Revision Suggestion for plan A

Joint
presented by
Nov 2016

Some issues for plan A

Suggestion for DS wavelength plan

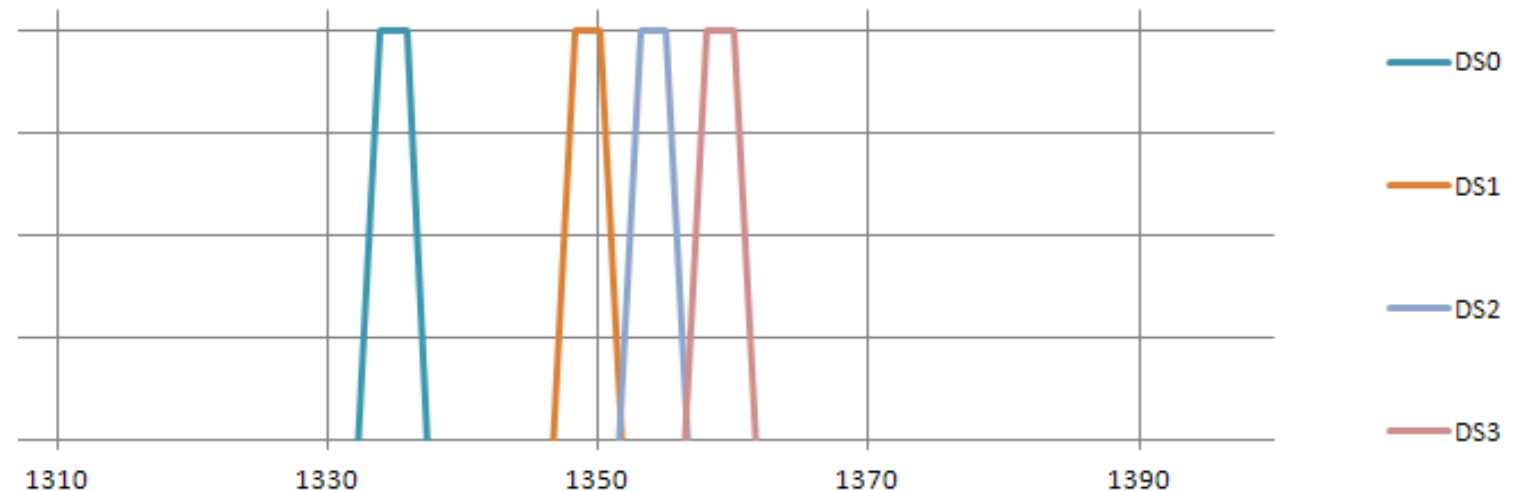
- DS1-DS0 Gap =7.6nm, which is < 10nm (focus beam requirement)
- Guardband between 10G US (1260nm-1280nm) is 9nm, which may not be safe enough
- FWM to be confirmed (upper bound of US2 is 1299.927, which is too close to lower bound of the ZD zone 1300nm)
- 2nm width of each US, which is very tight

- Pass band for downstream wavelength is 2nm now
- Gap between DS0 and DS1 can be enlarged from 1.6THz to 2.4THz
- Channel spacing for DS1 to DS3 is 800G Hz
- >10 nm Guard band for 25G ONU WBF
- Low cost BOSA is still available for 25G ONU

Center freq	Center WL
DS0	224.600	1334.784
DS1	222.200	1349.201
DS2	221.400	1354.076
DS3	220.600	1358.987

Wavelength blocking filter for 25G ONU

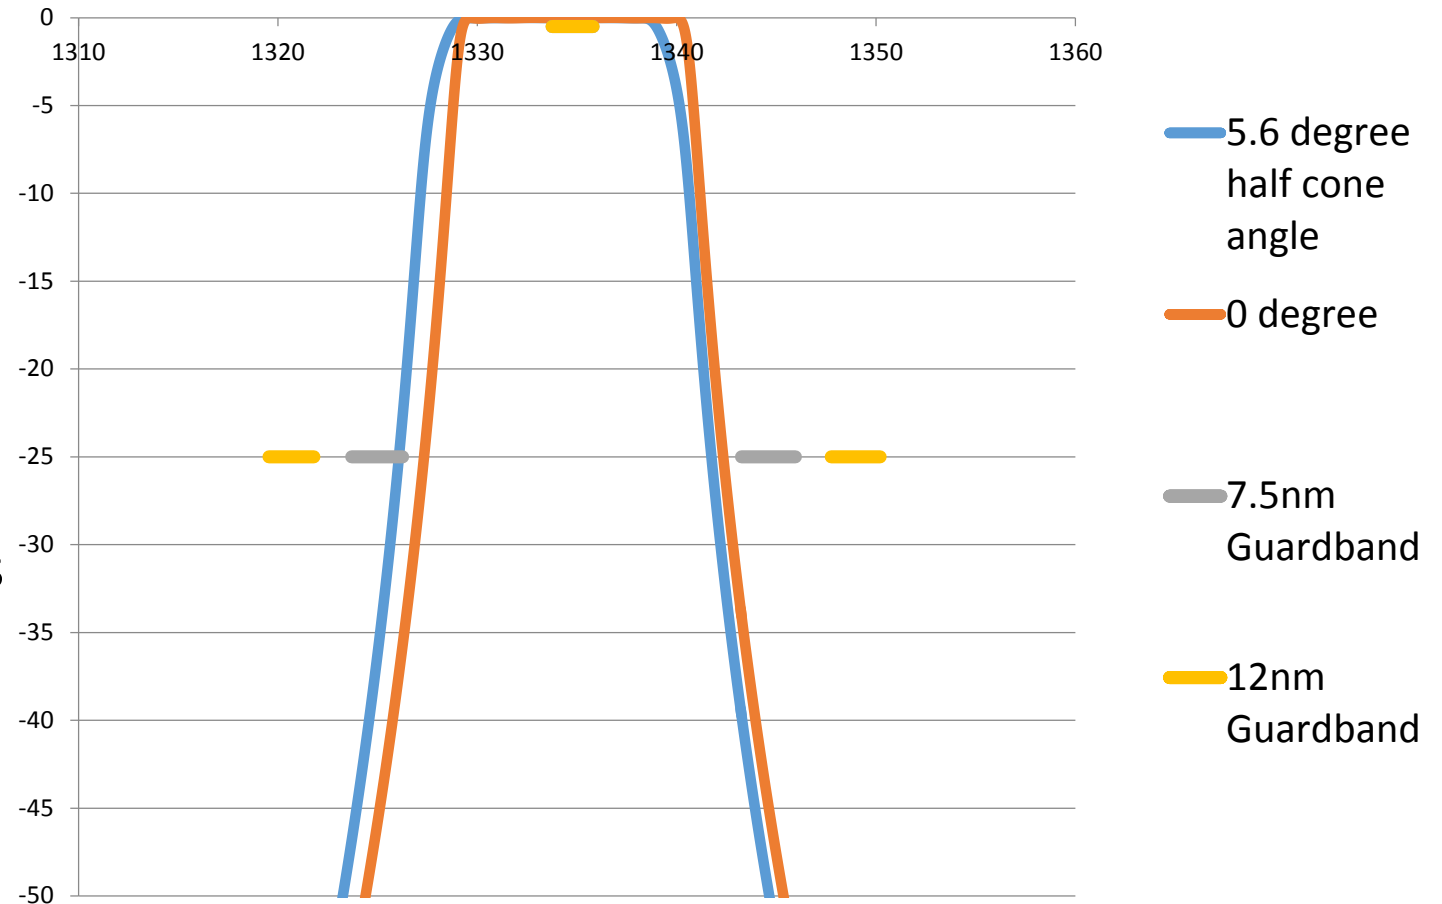
- WBF with 7.5nm guard band is technical feasible, but leads to very tight margin in volume production
- When guard band is enlarged to 12nm (gap between D0 and D1 is 2.4THz), better margin in volume production is possible

FWM analysis for plan A in worst case

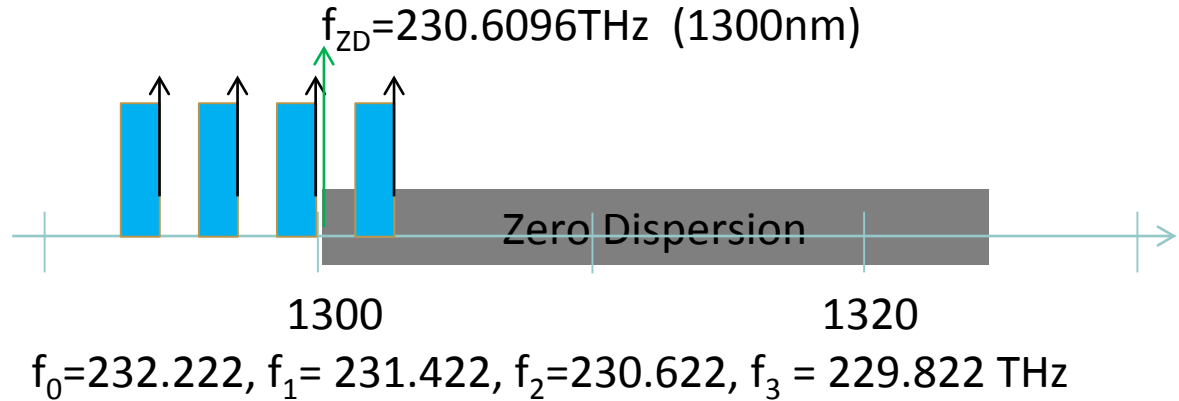
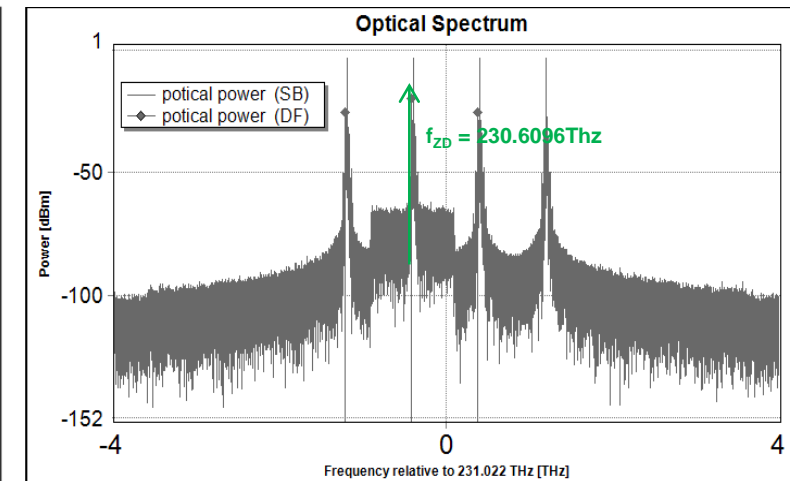
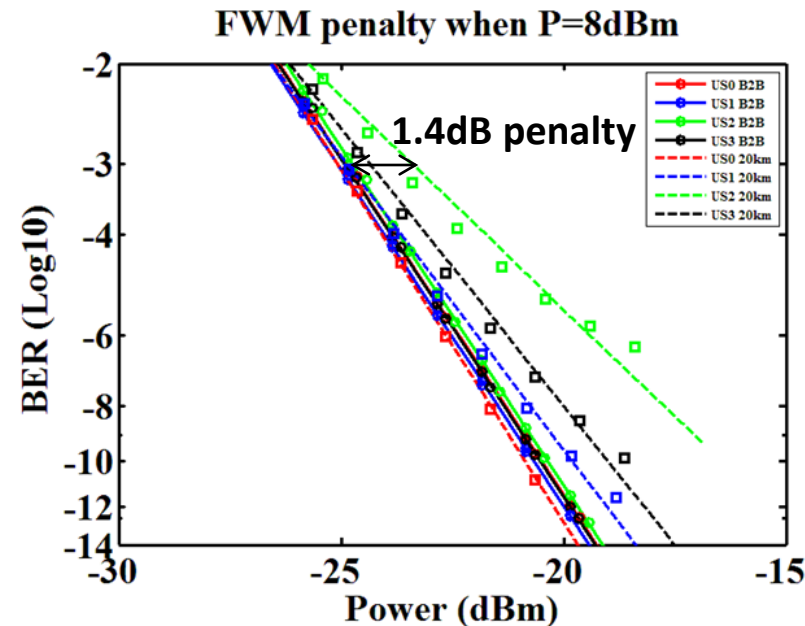
Due to in worst case, f_2 is only 12GHz(0.07nm) away from the zero dispersion zone, so some extent FWM penalty may still happen, especially in US2 channel ([1.4dB@1E-3](#)).

The probability and the conditions of the worst case should be considered in decision of final wavelength plan.

One revision for US plan and associated FWM analysis

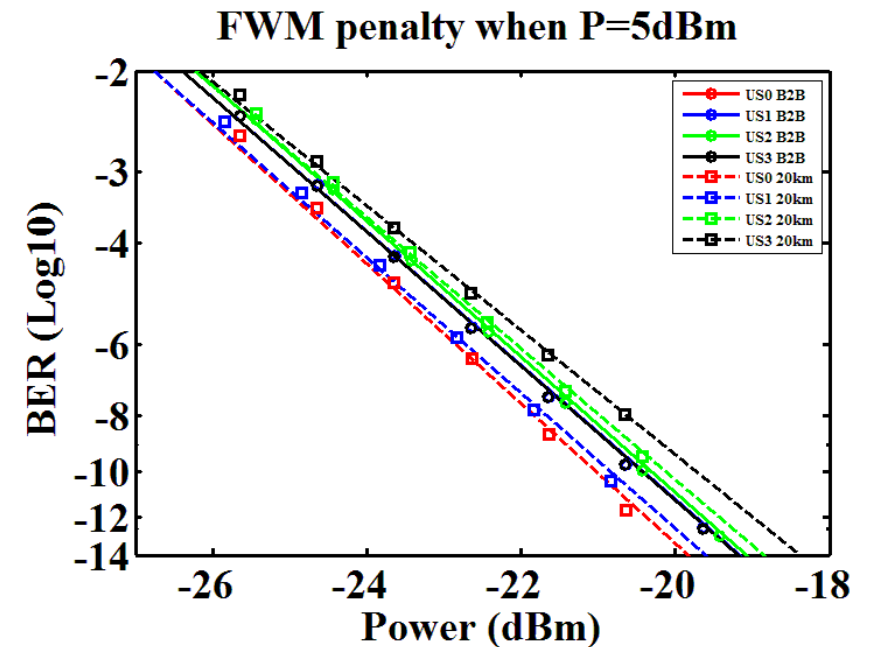
- [5dBm maximal power](#) for each channel is limited to avoid FWM penalty risk
- [3nm width for each US channel](#) relax the ONU wavelength tolerance and decrease the cost of optics
- [10.7nm guard band is left between 10G EPON and 25G EPON upstream](#)
- **5dBm maximal launch power limitation's impact on power budgets and optics cost needs further study**

Center freq	Center WL	PB width (THz)
US0	232	1292.21	0.54
US1	230.7	1299.49	0.54
US2	229.4	1306.85	0.54
US3	228.1	1314.30	0.54
